Technical Service Bulletin

MODEL(S) AFFECTED: Speed Scrub 300 Walk-Behind Scrubber

Models manufactured between S/N SS300-10885160-10894861

SUBJECT: Reduced battery run-time and/or BDI fails to display a full charge after a complete charge cycle.
 Root Cause: A diode was recently added to the wire harness to prevent potential control board failure if battery terminal connection is accidentally reversed. Reports claim the addition of the diode has caused a small voltage drop affecting the firmware to act as if the batteries are at a lower voltage.

9017921 Jumper Kit Contents

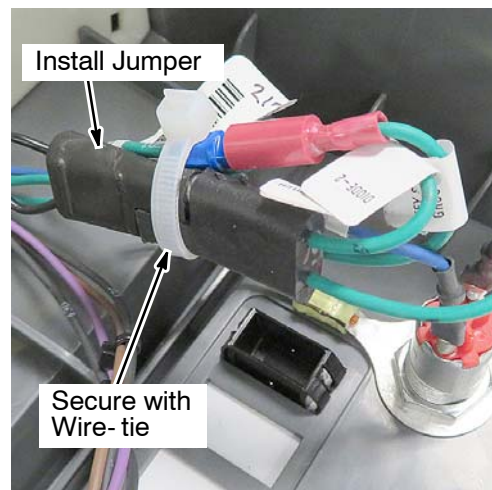
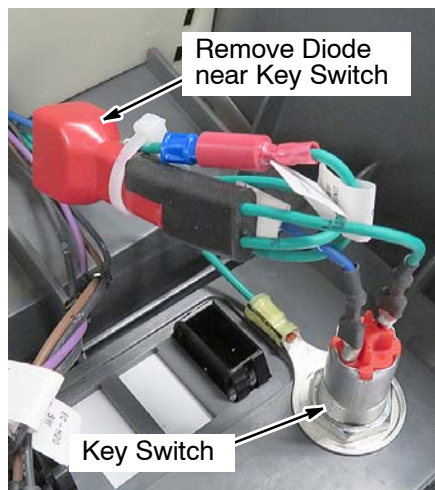
PURPOSE: To repair the above issue, the diode must be removed and replaced with Jumper Kit 9017921 as shown below. As an alternative option to repair issue, the diode connector plug can be cut from the wire harness and replaced with a spade terminal also shown below.

Install Jumper Kit to repair issue:

* The kit contents will include either a wire harness jumper or a plug connector jumper as shown above. Both serve the same purpose.
